Theater Missile Defense Extended Test Range

Final
Environmental Impact Statement

November 1994

Volume I begins with the Executive Summary and Acronyms and Abbreviations. Section 1.0 of the Final EIS contains the introduction. Section 2.0 contains the additions and revisions to the Draft EIS and to the Supplement to the Draft EIS. Section 3.0 contains the responses to comments that were made on the two documents, and Section 4.0 includes an index to the commenters. Section 5.0 contains the agency comment letters and responses that pertain to the Draft EIS and the Supplement to the Draft EIS, while Section 6.0 lists the references used in the preparation of the Final EIS. Section 7.0 contains the list of preparers of the EIS, and Section 8.0 contains the distribution list for the document. Section 9.0 contains copies of the transcripts, exhibits, and written comments pertaining to the Draft EIS relevant to the Western Range Candidate Test Area. Section 10.0 contains copies of the transcripts, exhibits, and written comments pertaining to the Draft EIS relevant to the Eglin Air Force Base Candidate Test Area. Appendix A contains a discussion of cumulative impacts for the EIS, and Ap

Figure 3.2-2

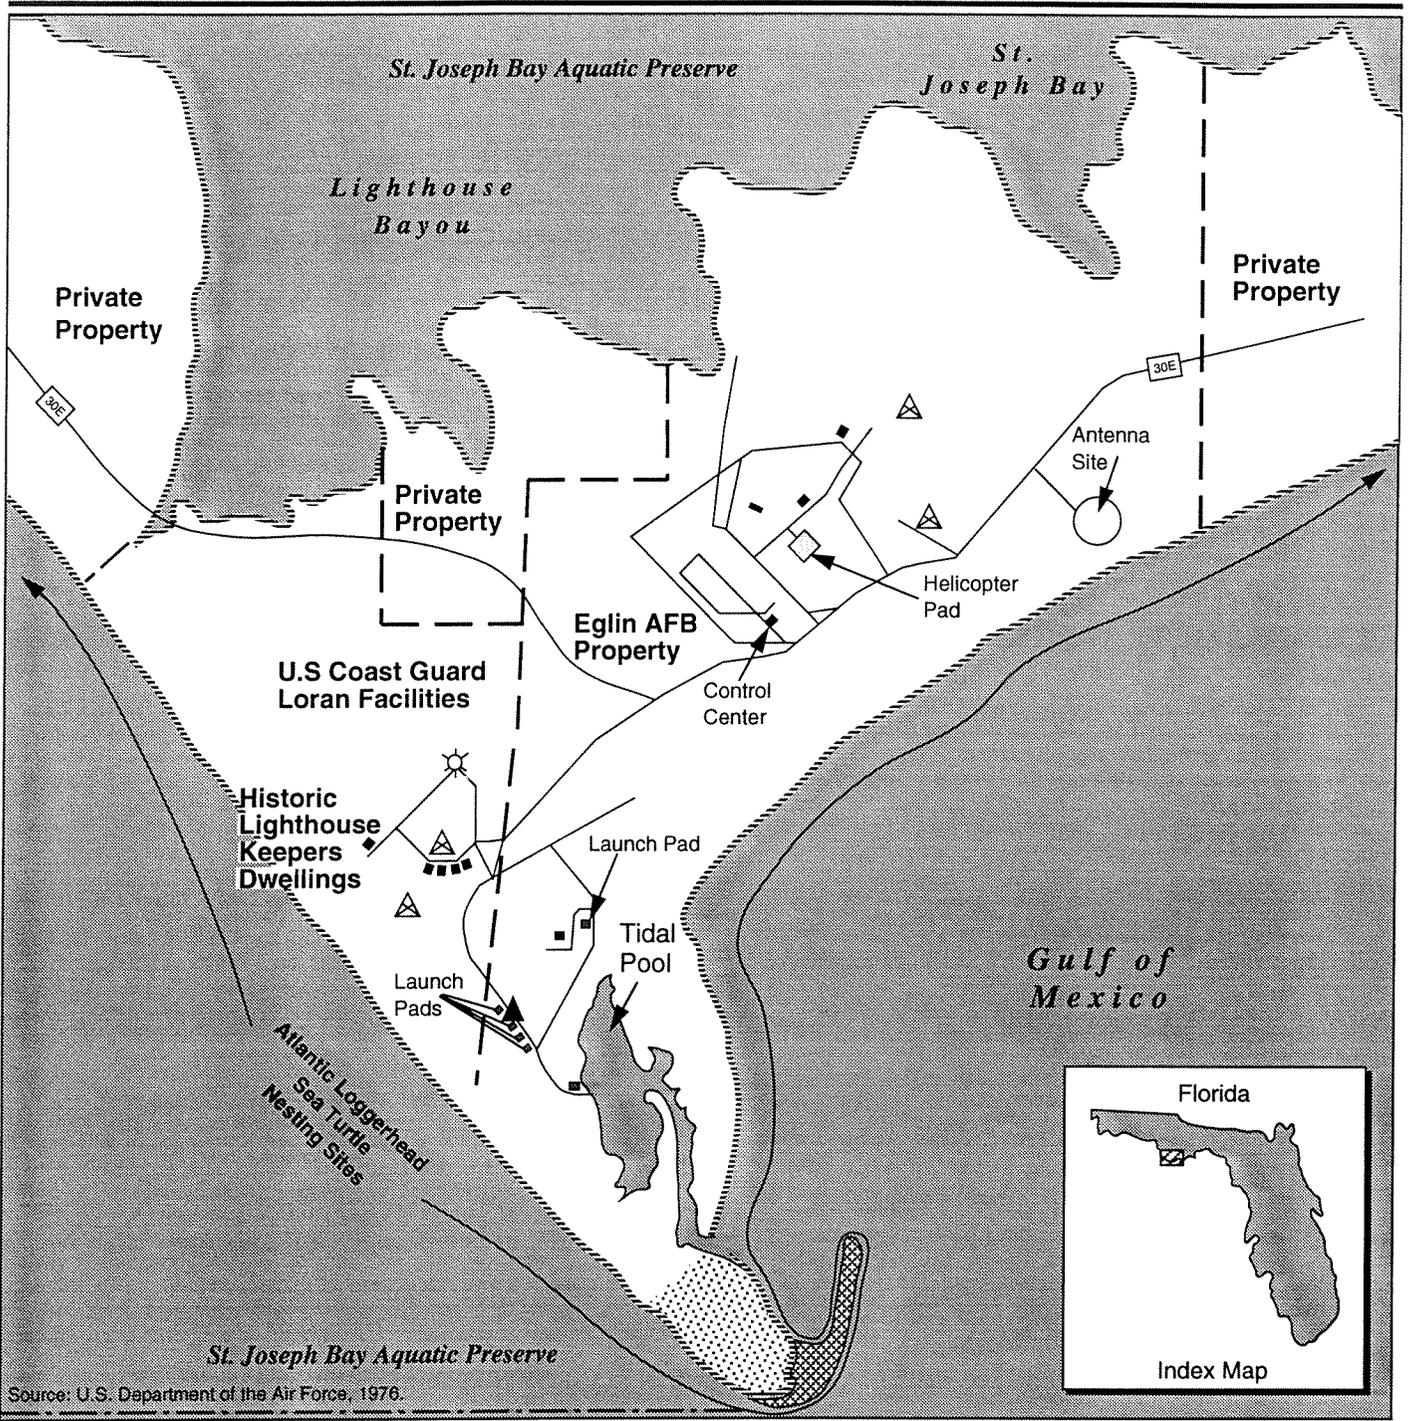
Page 3-119, figure 3.2-2: Figure has been revised as shown.

Figure 3.2-4

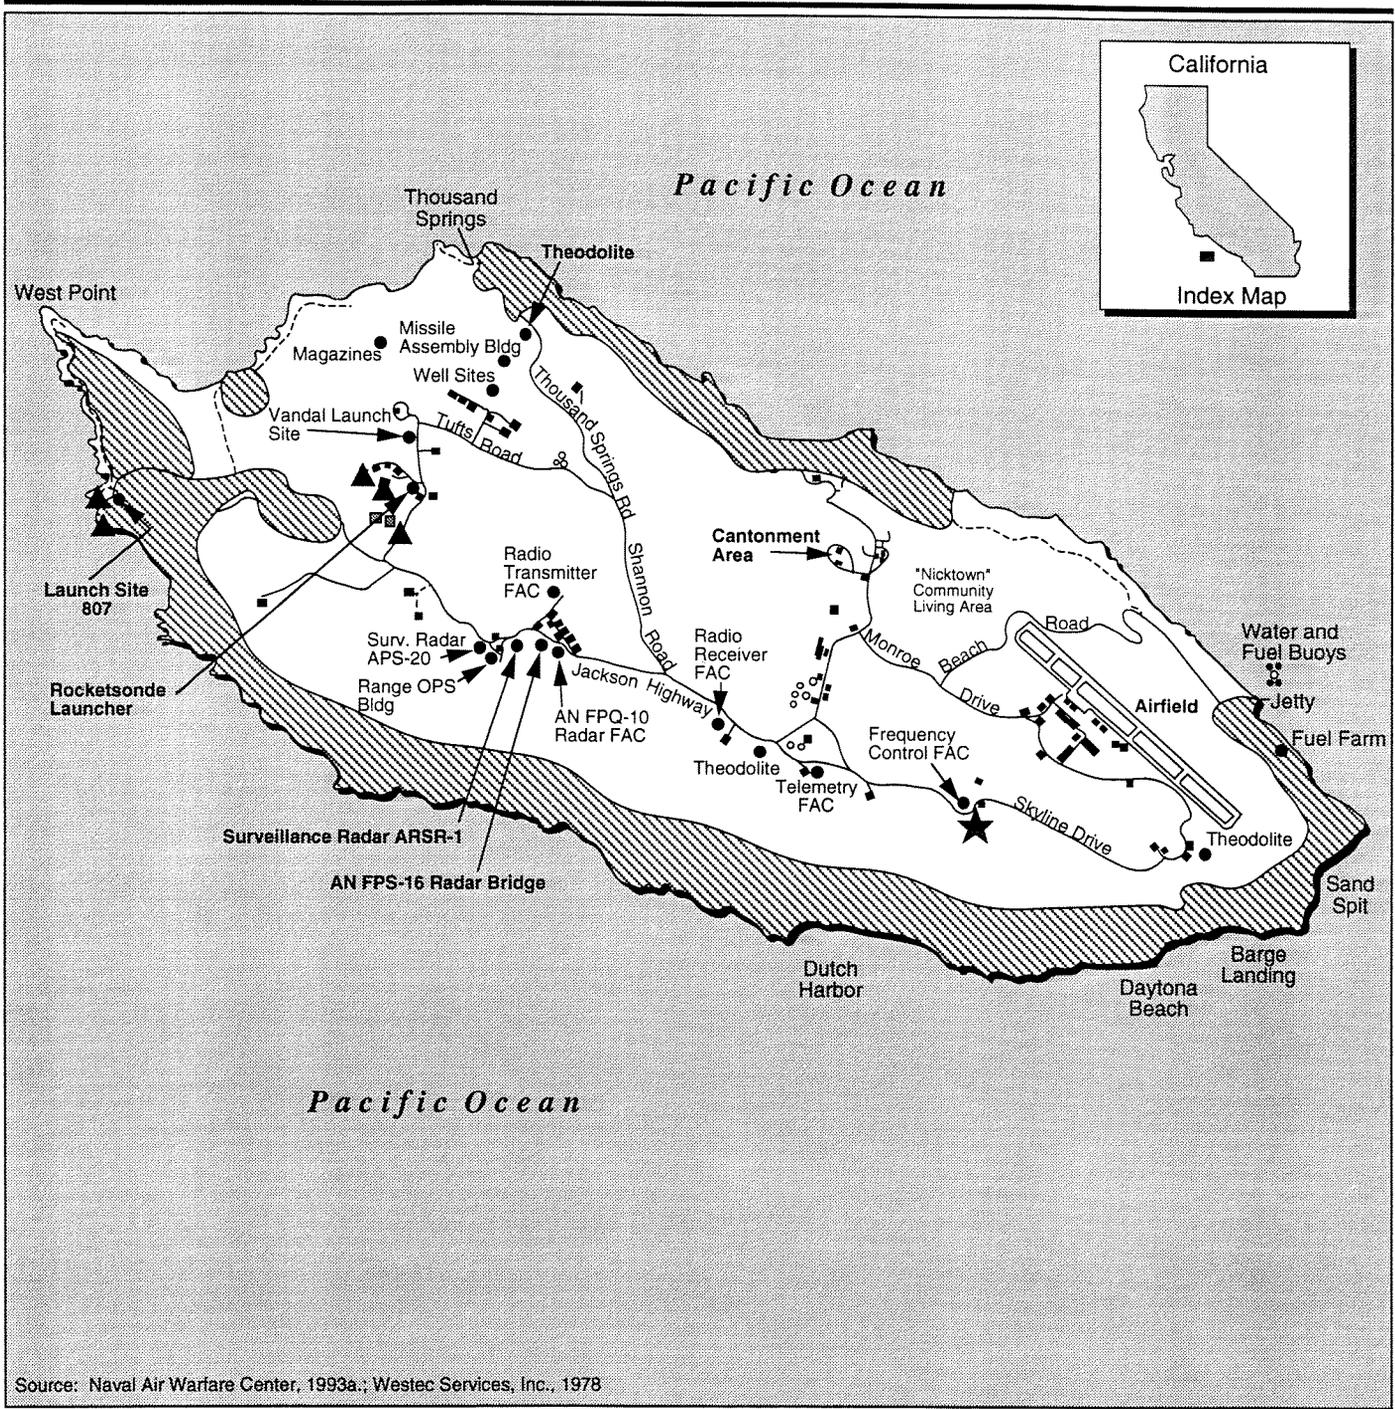
Page 3-137, figure 3.2-4: Figure has been revised as shown.

Figure 3.3-1

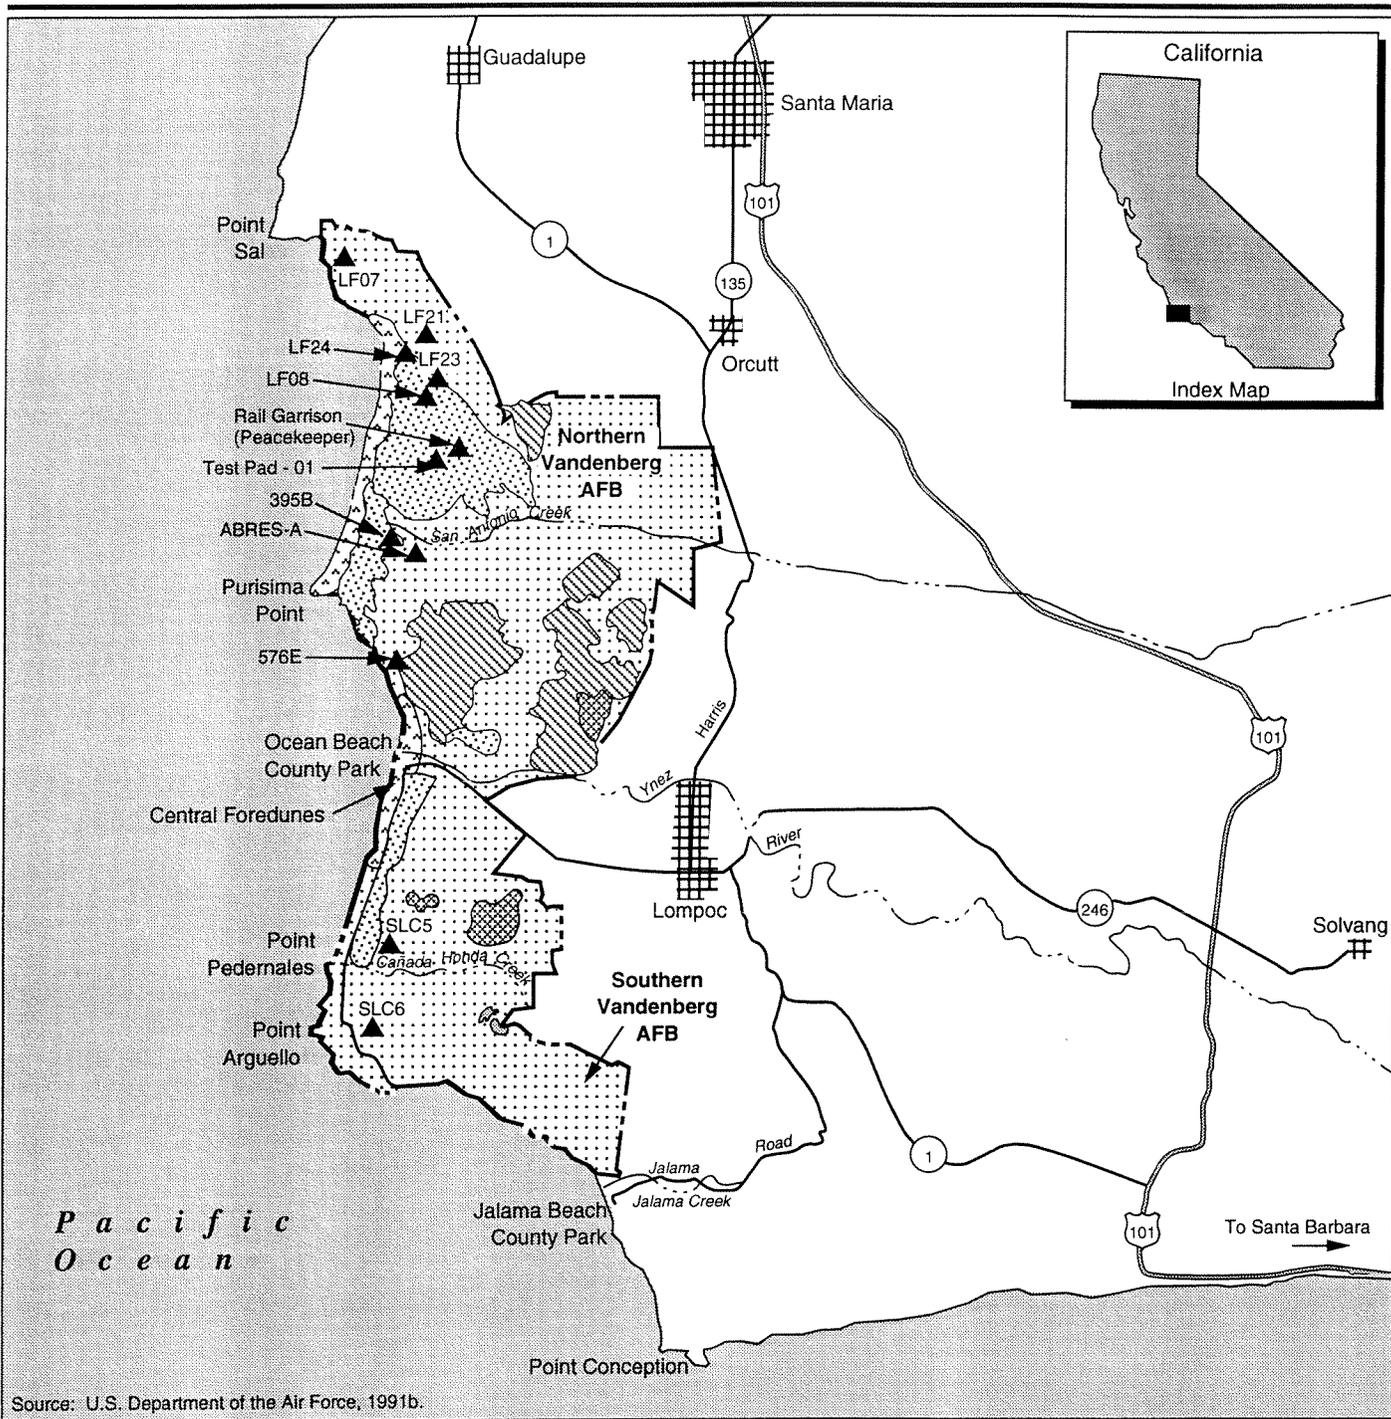
Page 3-167, figure 3.3-1: Figure has been revised as shown.

Figure 3.3-2

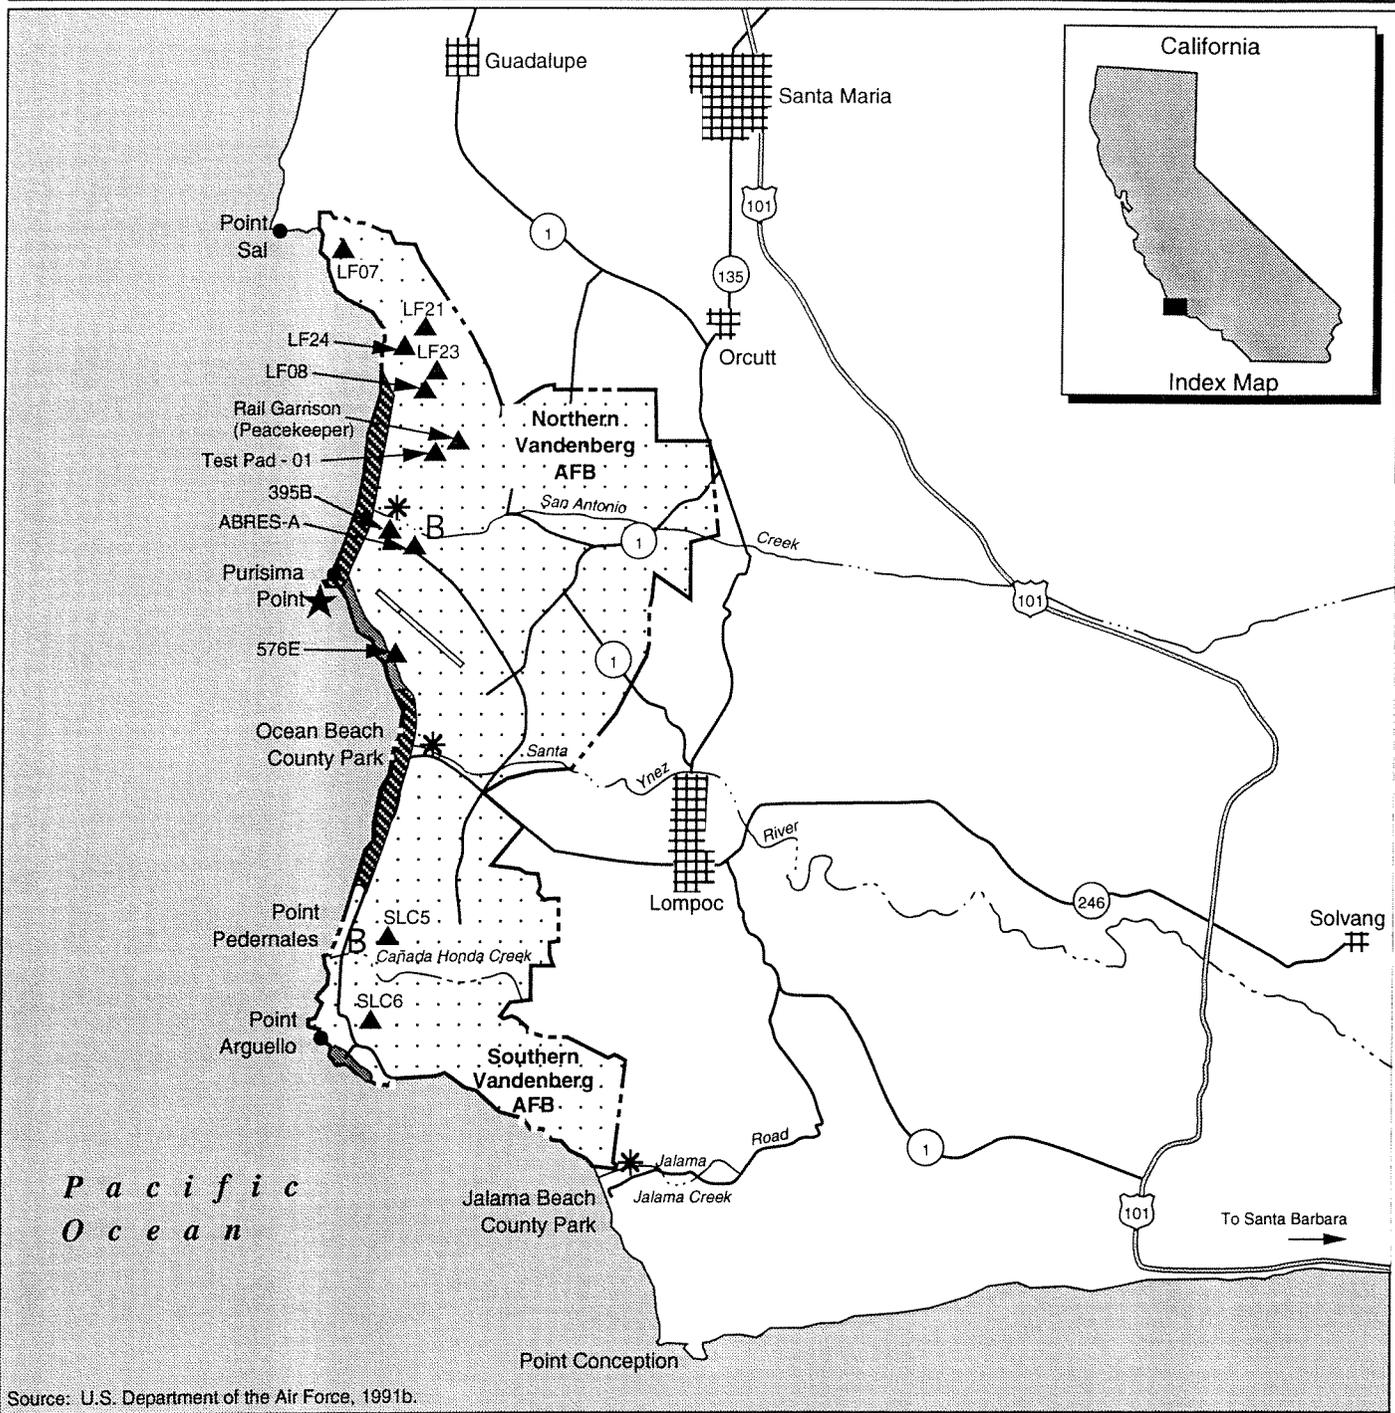
Page 3-168, figure 3.3-2: Figure has been revised as shown.

Figure 3.3-4

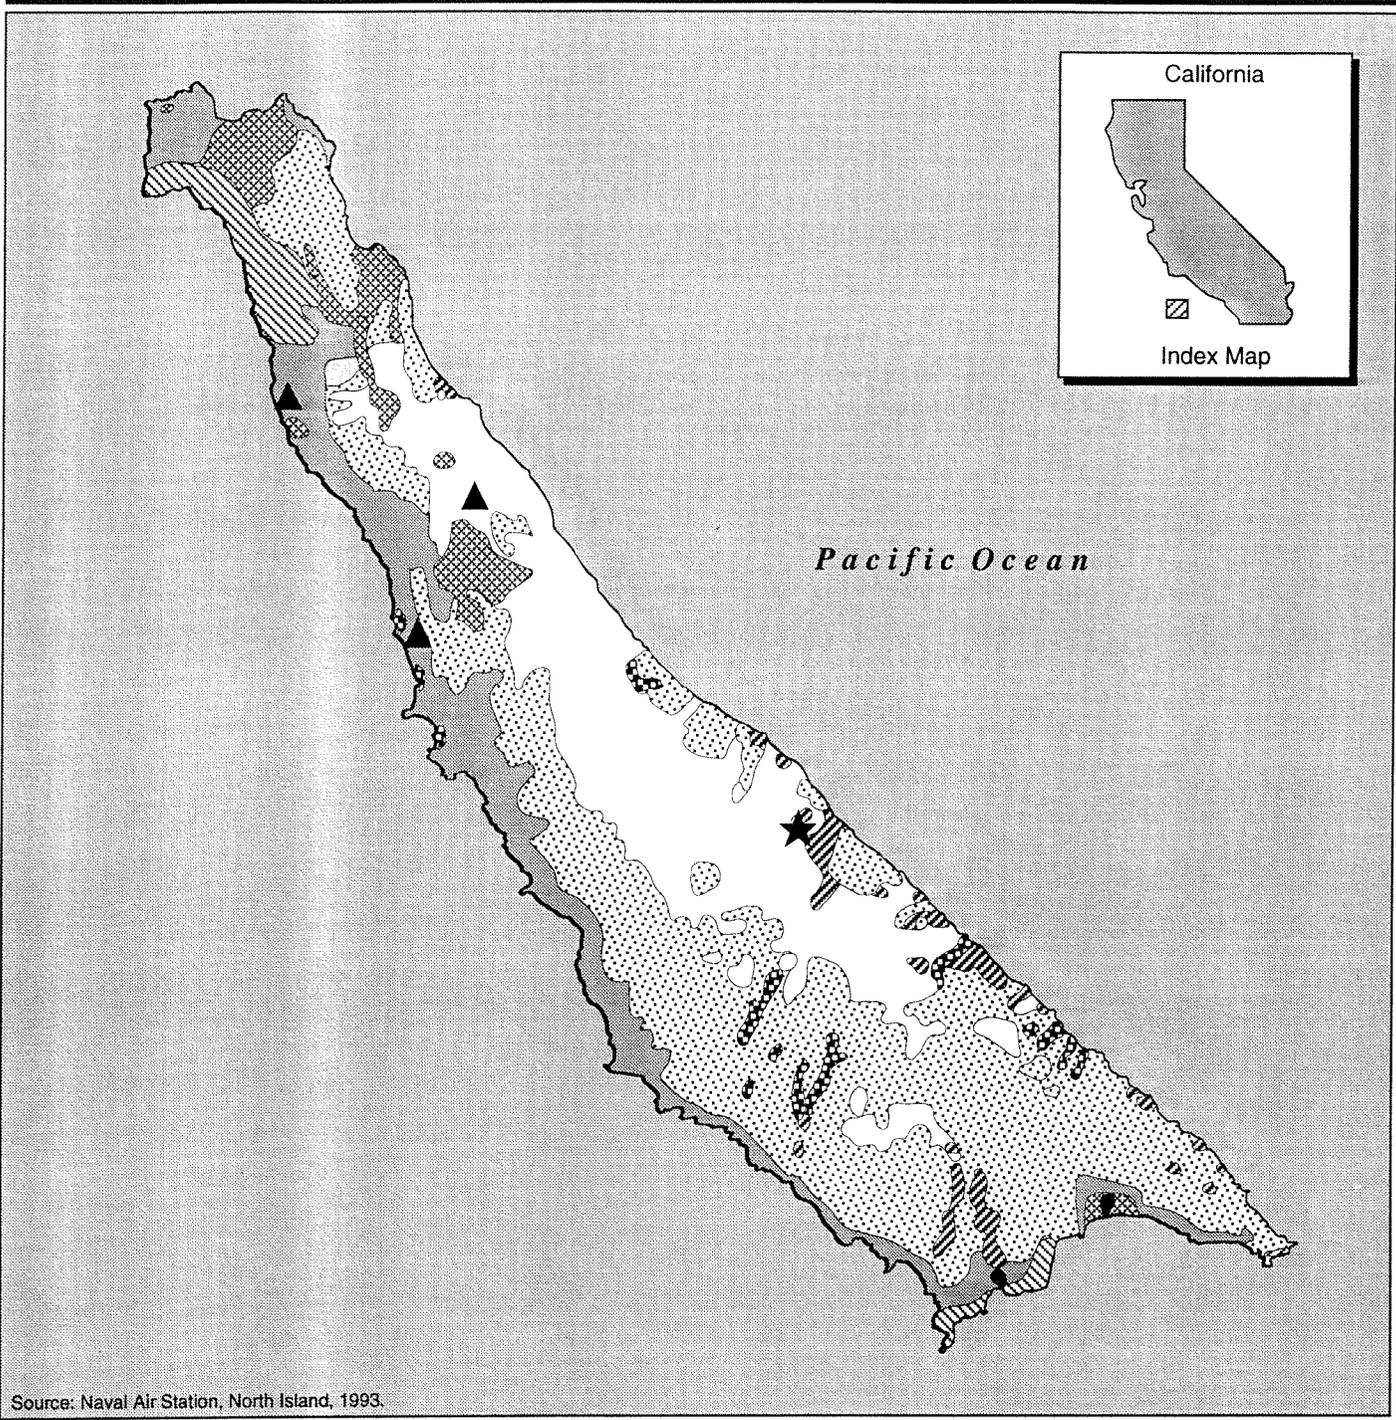
Page 3-189, figure 3.3-4: Figure has been revised as shown.
